核四廠一號機安全釋壓閥洩放管路(SRVDL)
系統查證研究報告

A Study of Safety Related System Inspection on SRVDL System of
Taipower's Fourth Nuclear Power Plant Unit 1

系統查證研究報告

附件六 Minimum wall thickness

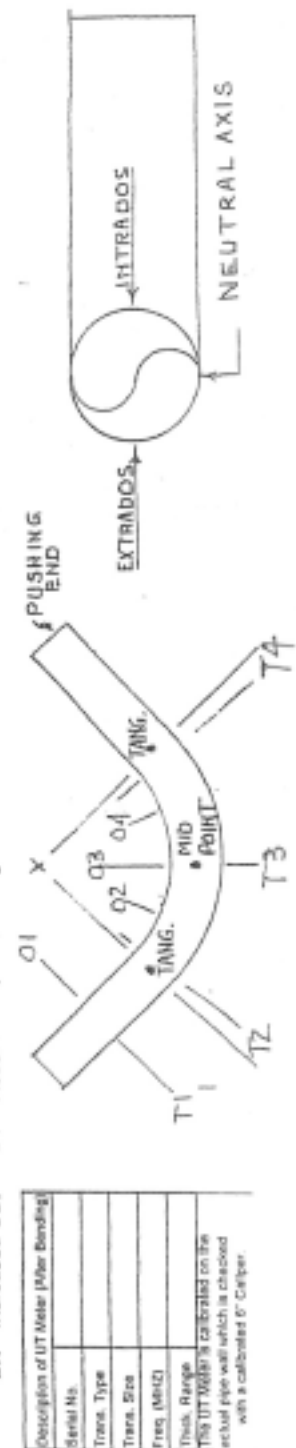
- (a) 1B21-PSP-004 超音波檢測報告中彎管有些管壁厚度低於規定最小值 (附件六)，BF Shaw 公司自行開立 NCR-1453 (附件七)，並通知 GE 公司要求解釋，GE 回覆文件 DDR-62.2213.1-8 (附件八) 中認為 BF

公司所量測之彎管厚度值仍然符合 B&V 公司 31113-0A10-2102 Rev.1 中之厚度需求 (0.475")。故該管件仍符合規定要求。

圖三：穿越器

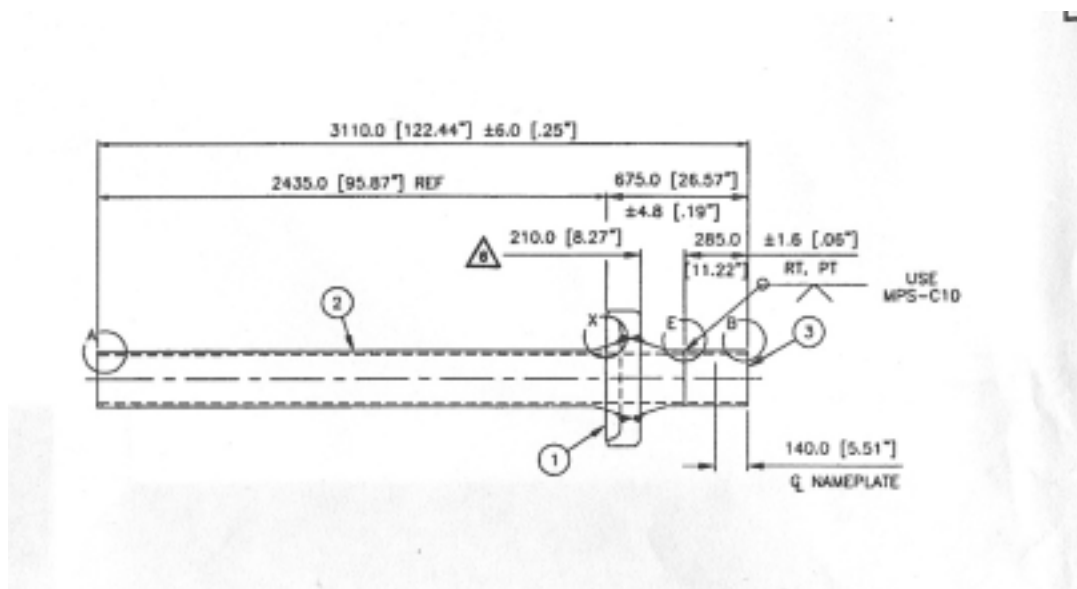
穿越器(如圖三)為 TAYLOR FORGE ENGINEERED SYSTEMS. INC. 製造，管材 SA182 Grade 316L 符合規範要求，並執行 PT 檢測，安裝在隔膜地板混凝土，為了與上游的碳鋼管銲接，穿越器於工廠製造時已事先銲接一截 SA-333 Gr6 碳鋼管，查證 1B21-MPEN-0008A 文件，材質符合規範要求，SA-333 Gr6 依規定執行水壓測試。依照 Purchase Specification for Containment Mechanical Penetration Assemblies 的 7.2.1 節規定穿越器要執行水壓測試(Hydraulic Tests)，但在 QRP 缺此項測試文件。

照片一、現場部分 SRVDL 不銹鋼管路上存有銲渣痕跡

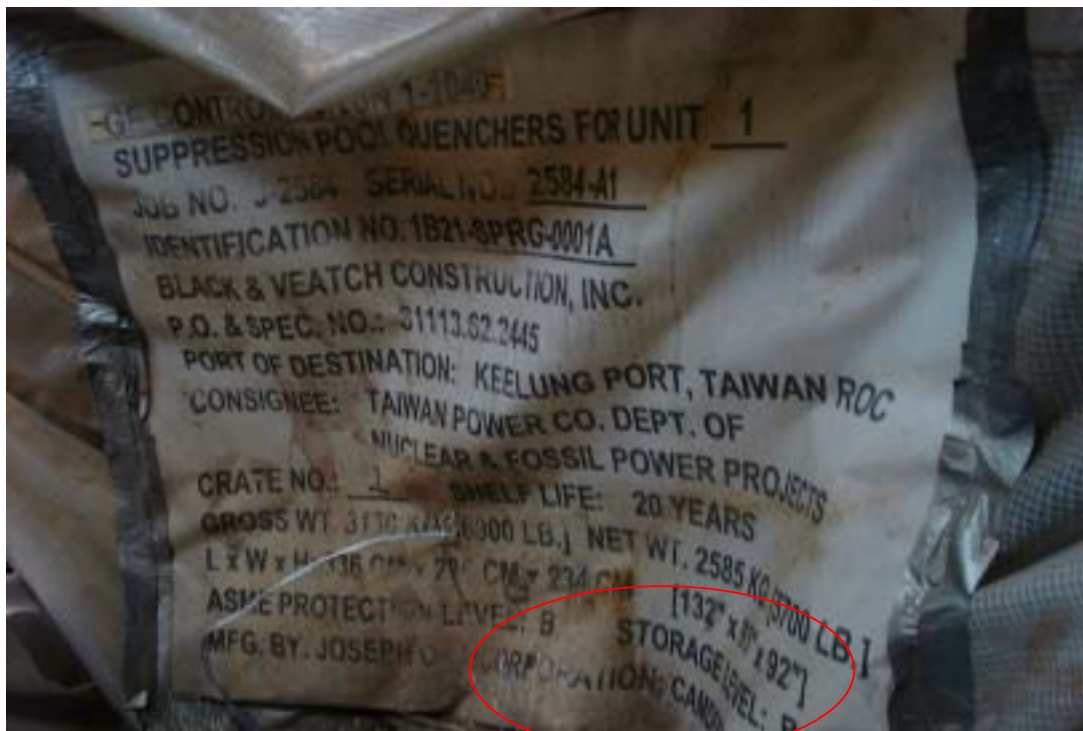
現場查證 SRVDL 系統重要組件倉儲現況，其中 Vacuum Breaker、Diaphragm floor 以上之碳鋼管、Mechanic Penetration 均置放於庫房或管路存放處，倉儲狀況符合規定。Diaphragm floor 以下之管件及 Quencher 等不銹鋼組件則已由汽源課領出，置放於濕井預計安裝處。視察發現，部分管路上存有銲渣痕跡(照片一)，且部分 Quencher 之保護膠套有灼傷焦黑之狀況(照片二)，已將此現象向主辦課反應，請其儘速妥善處理，以期提供設備品質更多保障。施工處已利用塑膠帆布覆蓋(照片三)，Quencher 設備保養維護已有改善。另依據 Quencher 上之組件說明(照片四)，原廠家要求之儲存等級為 B(室內儲存，室溫維持在 5°C 至 48°C 之間)，Quencher 放置現場為戶外且地面處於長期積水狀況，設備雖然已利用枕木架高，然而長期而言 Quencher 置放於濕井現場，其儲存條件應無法滿足原廠家之儲存等級要求。

照片二、現場部分 Quencher 之保護膠套有灼傷焦黑之狀況

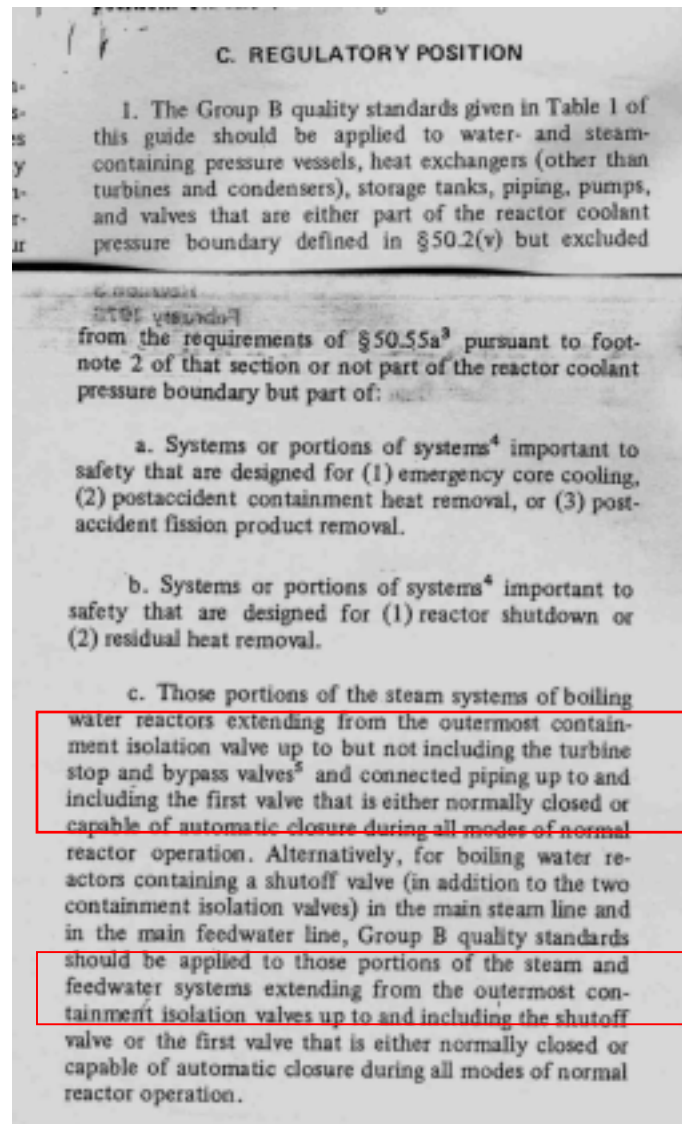
5.1 依據 ABWR 訓練教材第三篇第一章主蒸氣系統(B21-Main Steam System MS)敘述，肆、重要設備中第三、安全釋壓閥之 9. 釋放閥之排洩管之(2)各閥排洩管設有膨脹伸縮箱(Expansion Bellow)，供作閥動作時熱漲冷縮緩衝之用。但是查閱施工處之 P&ID 及 ISO 相關圖面資料，均未發現有膨脹伸縮箱或類似設備存在，特向核四廠原作者請教，但原作者表示因時間已久不復記憶，經其協助查閱 GE 之英文訓練教材及其原始文件 Main Steam System (MS) System Design Description 亦未發現類似敘述。再查閱核二廠相同系統設計狀況，根據核四廠提供之核二廠圖面，未發現類似設計。上述發現復請施工處汽源課確認後，證實訓練教材相關敘述應為錯誤，已建議台電公司予

以修訂。另外，訓練教材第二篇第四章 自動釋壓系統(Automatic Depressurization System ADS)圖八：SRV 與 MSIV 之相關參數設定中將 Non-ADS 之 SRV 歸類為 Non-Safety-Related，與 PSAR 之規定不符，亦建議台電公司一併修正。
